Access Compliance Report Public Rights-of-Way (Curb Ramps)

Main Street: ESENCIA_DR Cross Street: ANDAZA_ST Location: SE

ADA ID: RPRK211129124640 Ramp Type: Type 1 - Perpendicular Initial Pass/Fail: Pass Overall Compliance: No Severity Score: 0

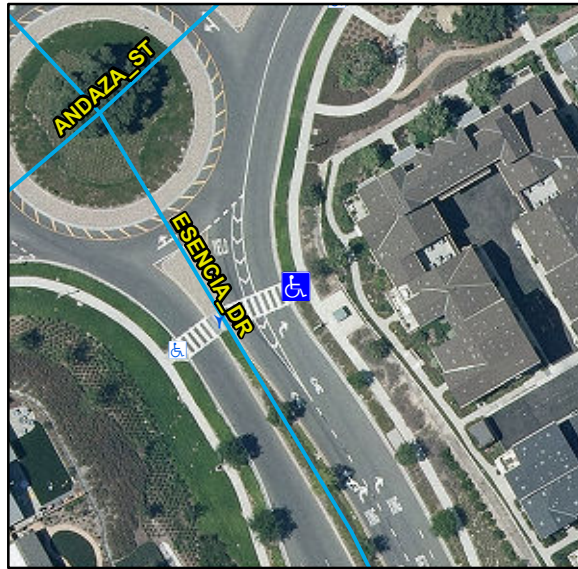
Yes	Ramp Inside Crosswalk 1	Yes	Yes	Ramp Inside Crosswalk 2	N/A
	Crossing 1 Slope (%)	2.5		Crossing 2 Slope (%)	N/A
	Crossing 1 Cross Slope (%)	1.4		Crossing 2 Cross Slope (%)	N/A
Yes	Gutter Ponding	No	No	Curb Slope	14.7
Yes	Gutter Lip Height (in)	0		Road Run Slope (%)	N/A
Yes	Gutter Run Slope (%)	4.7		Road Cross Slope (%)	N/A
Yes	Gutter Cross Slope (%)	0.8			
Yes	Overall Surface Condition: Acceptable		Yes	Perp Joint Present	Yes
	Cross Gutter Present?	No		Spandrel Present?	No
	Replace Cross Gutter?	N/A		Replace Spandrel?	N/A

Remove & Replace Curb Slope.

R304.2.2, STD 1115
